US 301: SECTION 3 - SOUTH OF DE/MD LINE TO LEVELS ROAD

301 US 301 Project Development

Section 3:

US 301, South of the MD/DE Line to Levels Road Extended, including:

Slight shift of New US 301 Mainline to east to avoid electric transmission towers

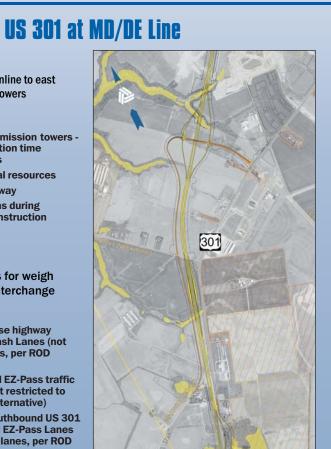
- Avoids major electric transmission towers reduces cost and construction time required to relocate towers
- Reduces impacts on natural resources
- Reduces required right-of-way
- Reduces MOT complications during Strawberry Lane bridge construction
